# Access Compliance Report

## Public Rights-of-Way

Intersection ID: 28659	Main Street: HAMPTON_PLACE_DR	Cross Street: RIDGELINE_LN	Location: S
ADA ID: F47B3A6E1CCB	Ramp Type: PerpDiag	Initial Pass/Fail: Fail	Overall Compliance: No
Codes/Mitigation Info/Possible Solution		Field Measurements/Component Compliance	
Severity Score: 8.75

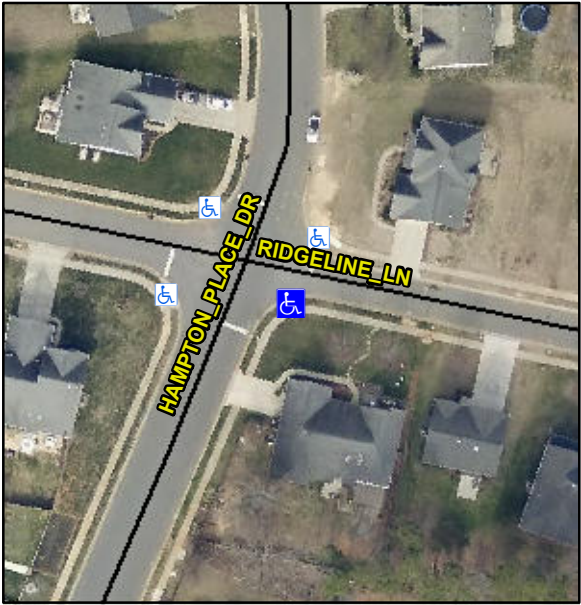
Possible Solutions:		Compliance		Description		Data	Compliance	Description	Data
	Remove & Replace Curb Ramp With Two New Directional Ramps or Equivalent.		N/A		Ramp Length (in)		48.0	Yes	Ramp Slope (%)	5.1
<p>Surveyor Notes:</p> <p>N/A</p> <p>PROW/ADA:</p> <p>Not Found, R304.5.1</p>			No		Ramp Width (in)		44.0	Yes	Ramp XSlope (%)	1.1
			N/A		Flare Type LT		N/A	N/A	Flare Type RT	N/A
			N/A		Flare Slope LT (%)		N/A	N/A	Flare Slope RT (%)	N/A
			N/A		Flare Traversable LT?		N/A	N/A	Flare Traversable RT?	N/A
			N/A		Landing Length (in)		N/A	N/A	DWS Provided?	N/A
			N/A		Landing Width (in)		N/A	N/A	DWS Contrast?	N/A
			N/A		Landing Slope (%)		N/A	N/A	DWS Length (in)	N/A
			N/A		Landing X Slope (%)		N/A	N/A	DWS Full Width?	N/A
			N/A		Landing Curb? (Y/N)		N/A	N/A	DWS Offset (in)	N/A
			N/A		Shared Landing?		N/A			
			N/A		Gutter Ponding?		N/A	N/A	Gutter Slope (%)	N/A
			N/A		Gutter Lip Ht (in)		N/A	N/A	Gutter X Slope (%)	N/A
